SUBJECT: INDIAN POINT NUCLEAR GENERATING UNIT NOS. 2 AND 3 - STAFF ASSESSMENT OF INFORMATION PROVIDED PURSUANT TO TITLE 10 OF THE *CODE OF FEDERAL REGULATIONS* PART 50, SECTION 50.54(f), SEISMIC HAZARD REEVALUATIONS FOR RECOMMENDATION 2.1 OF THE NEAR-TERM TASK FORCE REVIEW OF INSIGHTS FROM THE FUKUSHIMA DAI-ICHI ACCIDENT (TAC NOS. MF3717 AND MF3718)

STAFF ASSESSMENT BY THE OFFICE OF NUCLEAR REACTOR REGULATION

RELATED TO SEISMIC HAZARD AND SCREENING REPORT

INDIAN POINT ENERGY CENTER, UNIT NOS. 2 AND 3

Figure 3.3-1 Plot of Staff's and Licensee's Base Case Shear-Wave Velocity Profiles

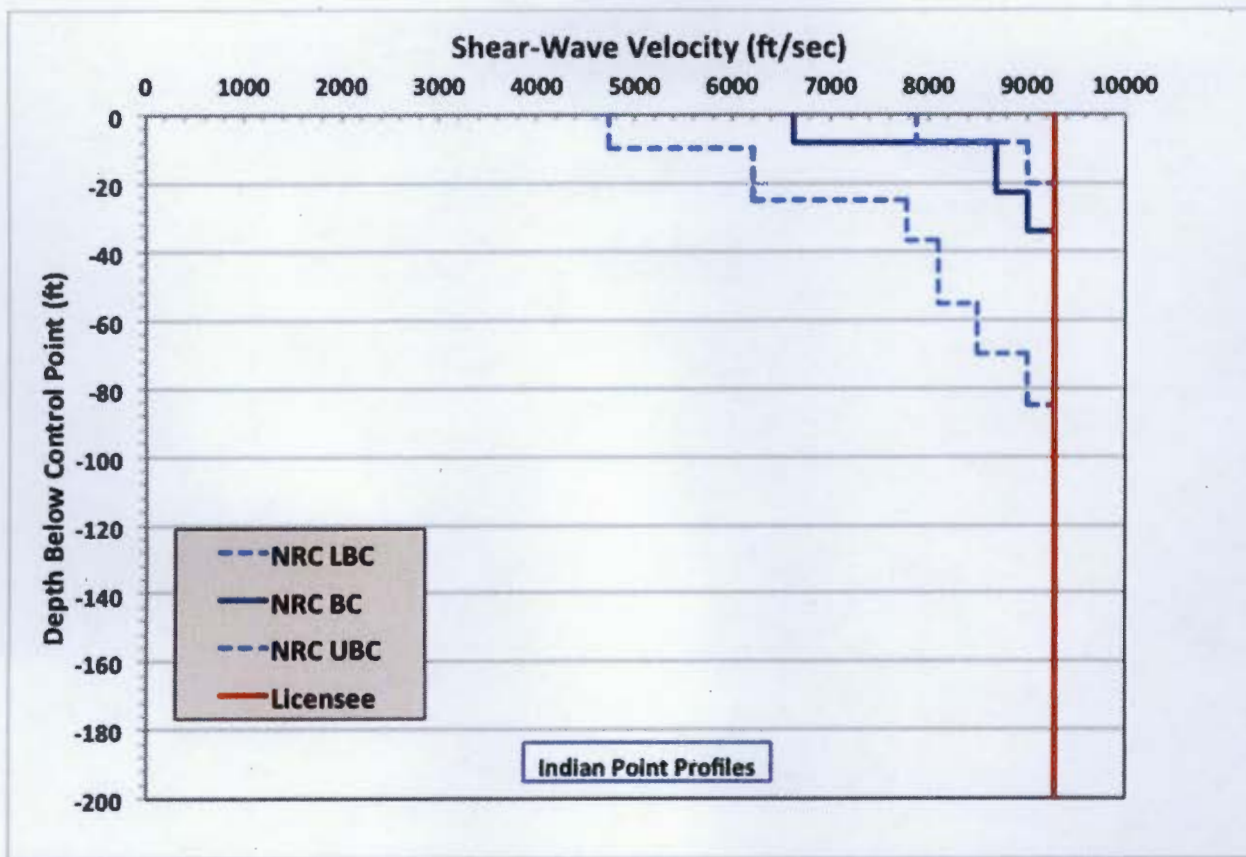
The staff used the information summarized above to develop a range of near-surface firm rock shear velocity estimates for the Indian Point site. As these velocities range from 4,900 to 9,600 ft/sec (1,493 to 2,926 m/sec), the staff developed three base cases with velocity values at the control point of 4,900, 6,800 and 8,400 ft/sec (1494, 2073, and 2561 m/sec) for the lower, best estimate and upper base cases, respectively. The staff then used the SPID template velocity profiles for firm rock site conditions to extrapolate the near surface velocities to depth. Figure 3.3.1 of this assessment shows the three base case velocity profiles developed by the staff.

Figure 3.3-2 Comparison of the Licensee's and NRC Staff's Median Amplification Functions and Uncertainties (Sigma Ln(AF)).

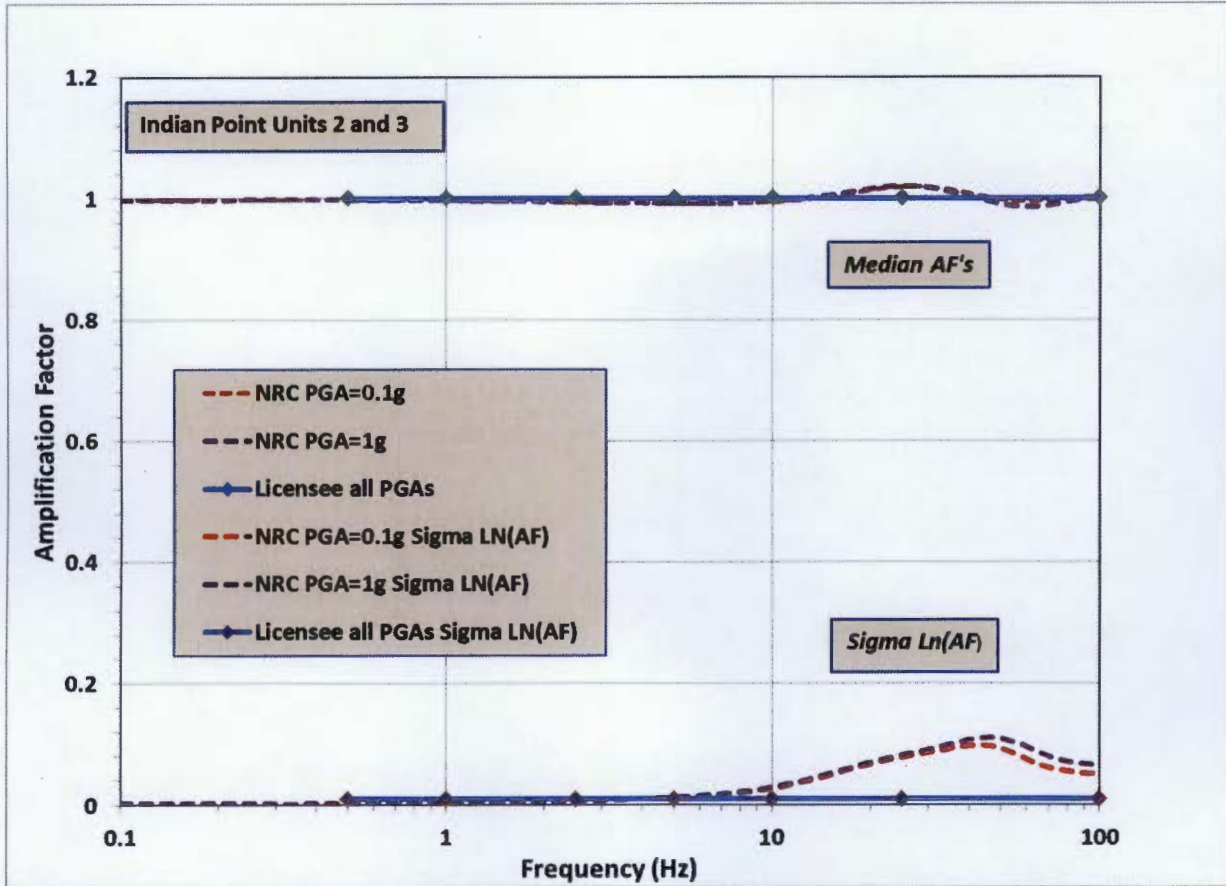
After randomizing each of the three base case profiles and implementing the random vibration theory (RVT) approach to perform the site response calculations, the staff developed site amplification functions. These amplification functions and associated uncertainties for two input loading levels are shown in Figure 3-3.2 of this assessment. The amplification functions produced using the staff's three base case models are very close to unity and the uncertainty is also relatively low, which is consistent with the licensee's determination that a site response analysis for this site is not warranted. Because the licensee did not perform a site response analysis, its amplification function is one and the uncertainty in the amplification function is zero.

Figure 3.3-3 Comparison of NRC Staff's and the Licensee's Mean Control Point Hazard Curves at Selected Frequencies

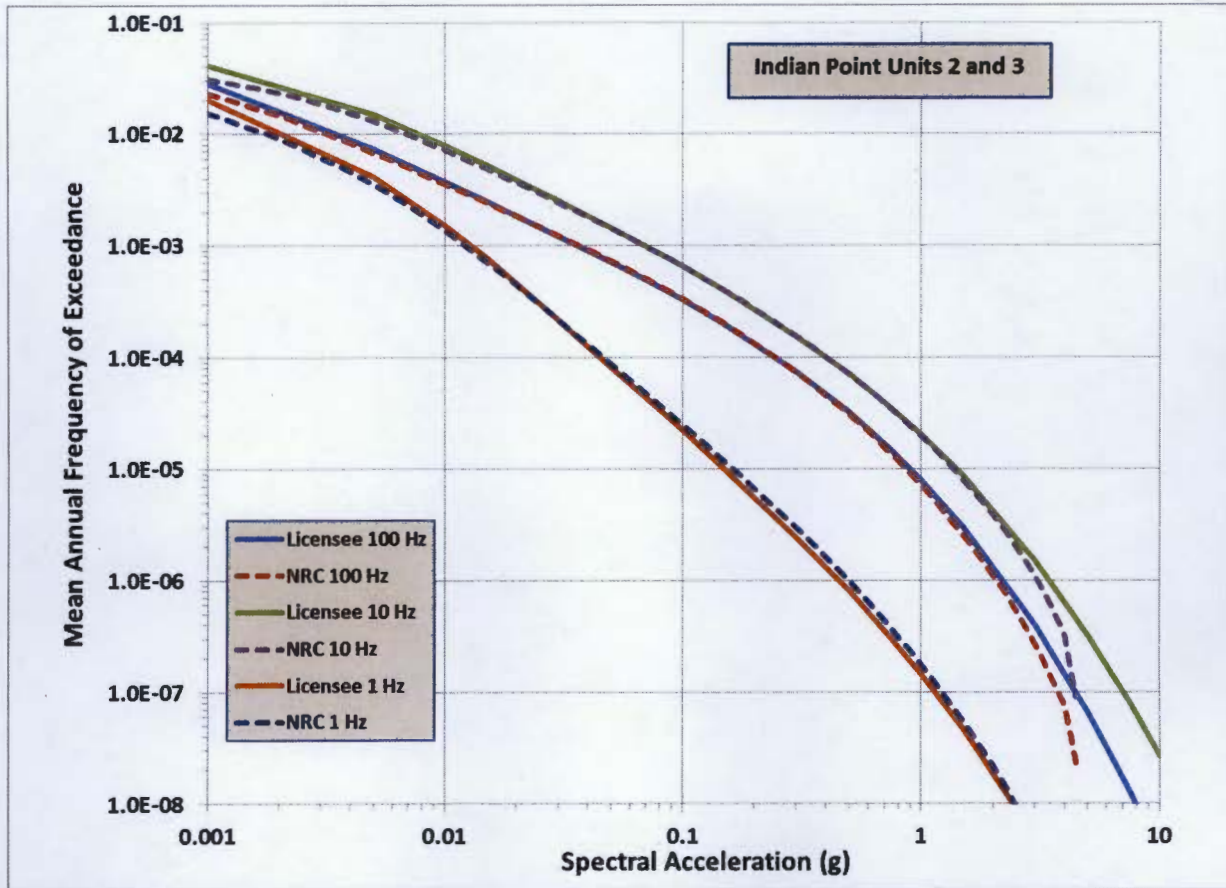
The NRC staff applied Approach 3, as described in Appendix B of the SPID, to compute the probabilistic site-specific control point hazard curves. Figure 3.3-3 of this assessment compares the NRC staff control point hazard curves in comparison to the licensee's hard rock hazard curves, presented in Section 2.3.7 of the SHSR submittal. As shown in Figure 3.3-3, the impact of the staff including the stiff near-surface materials in its site response analyses is generally minimal on the control point seismic hazard curves for mean annual exceedance frequencies greater than 1×10^{-6} per year.

In conclusion, as shown in Figure 3.3-3 of this assessment and discussed below, the staff's site response analysis does not produce significantly different control point seismic hazard curves or the resulting GMRS. Appendix B of the SPID provides guidance for performing site response analyses, including capturing the uncertainty for sites with less subsurface data; however, the guidance is neither entirely prescriptive nor comprehensive. As such, various approaches in performing site response analyses, including the modeling of uncertainty, are acceptable for this application.

In summary, the staff concludes that the licensee's evaluation was conducted using present-day guidance and methodology, including the SPID. The staff performed independent calculations which confirmed that the licensee's control point hazard curves adequately characterize the hazard for Indian Point.

Figure 3.4-1 Comparison of the Staff's GMRS with Licensee's GMRS and the Indian Point Unit No. 2 SSE

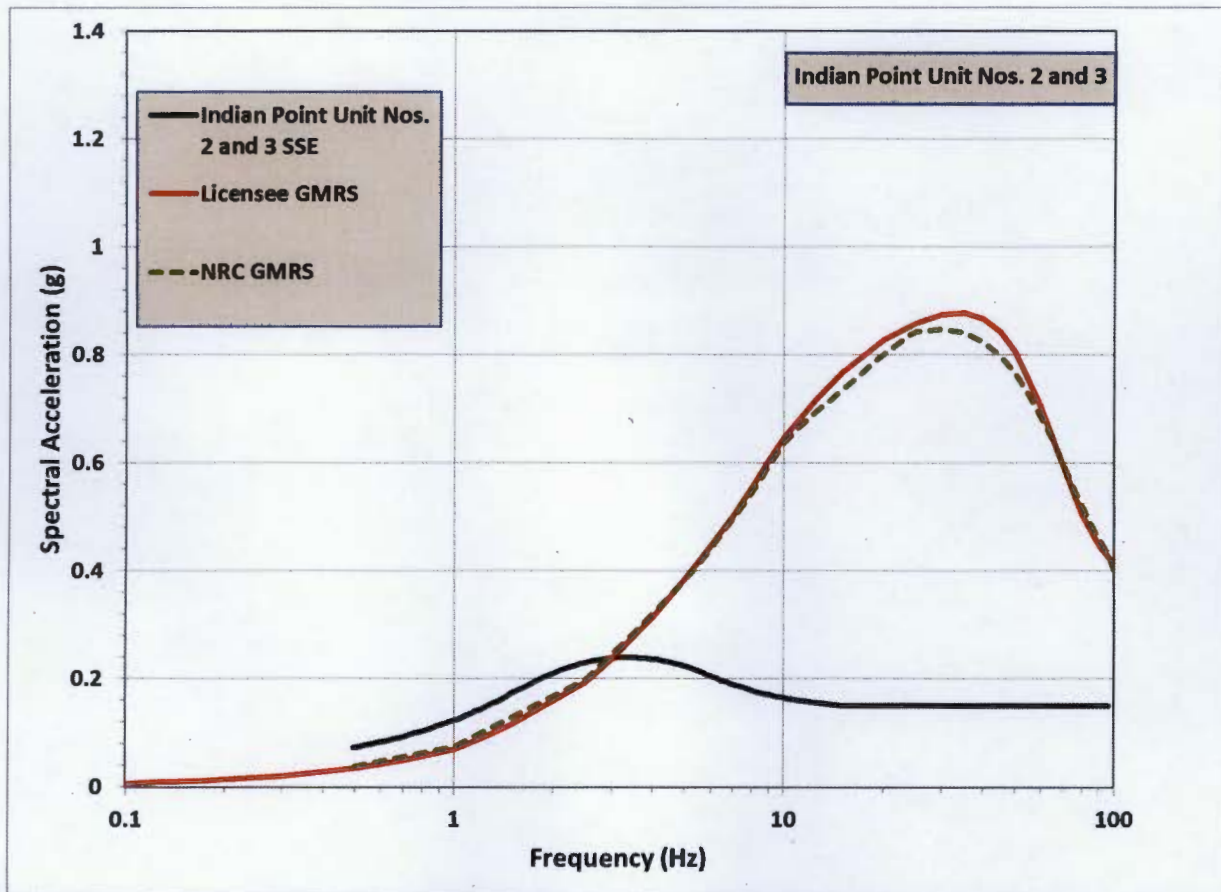
The staff independently calculated the 10^{-4} and 10^{-5} UHRS using the results of its confirmatory PSHA, as described in Sections 3.2 and 3.3 of this staff assessment, respectively. Figure 3.4-1 of this assessment shows a comparison of the GMRS determined by the licensee to that determined by the staff.

As shown in Figure 3.4-1 of this assessment, the staff's GMRS is very similar to the licensee's in both amplitude and shape. Both the licensee's and staff's GMRS exceed the SSE for both Indian Point Units 2 and 3 for all frequencies above 3 Hz. The staff confirms that the licensee used the present-day guidance and methodology outlined in RG 1.208 and the SPID to calculate the horizontal GMRS, as requested in the 50.54(f) letter. The staff performed a PSHA confirmatory

analysis and achieved results consistent with the licensee's results. As such, the staff concludes that the control point hazard curves (and GMRS) determined by the licensee adequately characterize the seismic hazard for the Indian Point, Units 2 and 3 site. Therefore, the licensee's hazard results are suitable for use in subsequent evaluations and confirmations, as needed, for the response to the 50.54(f) letter.
